# UNITED STATES PATENT AND TRADEMARK OFFICE

APPLICATION NO.	FILING DATE	FIRST NAMED INVENTOR	ATTORNEY DOCKET NO.	CONFIRMATION NO.
09/871,229	05/31/2001	Yu-Hwa Lo	NOVA-014	1700

**Office Action Summary**

## **DETAILED ACTION**

**FIG. 8**

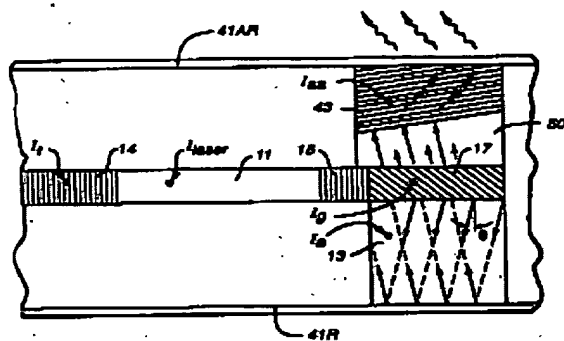
Claims 1-12,17,18,25-27,32-34,39-45 are rejected under 35 U.S.C. 102(b) as being anticipated by Scifres et al (PN 5,103,456).

Figure 8 illustrates a laser system formed within a common substrate, where the system is composed of a laser (11) having a cavity established by reflectors (14) and (15) the emitted light from the laser is deflected by an angled grating (17) towards mirror (41R), where the is reflected towards an output coupler (41AR) or alternatively (43). Output coupler grating (43) provides diffraction of the light, which will change the profile of the output beam. See column 3 lines 10-20, column 6 lines 51-68 and column 7 lines 1-26.

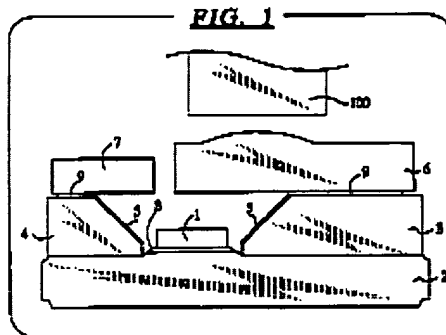
Scrifes et al discloses using an output-coupling grating for diffracting the output light beam, but does not disclose using a lens for providing the output diffraction of the light beam.

Spaeth et al discloses in column 2 lines 45-50 and illustrates in figure 1 the use of a lens (6), which is capable of diffracting or refracting an output light beam from a surface emitting semiconductor laser, therefore it would have been obvious to any person having ordinary skill in the art at the time the invention was made to disposed at the output of a surface emitting semiconductor, as in the laser of Scrifes et al, a lens, as the lens of Spaeth et al, because the lens has the capability of diffracting the output light beam.

Monitoring the light beam of a laser system is well known in the laser art, Spaeth et al discloses in column 2 lines 65-67 and illustrates in figure 1 the use of monitoring chip, which is one of many techniques used for monitoring or detecting the light beam of a laser system.
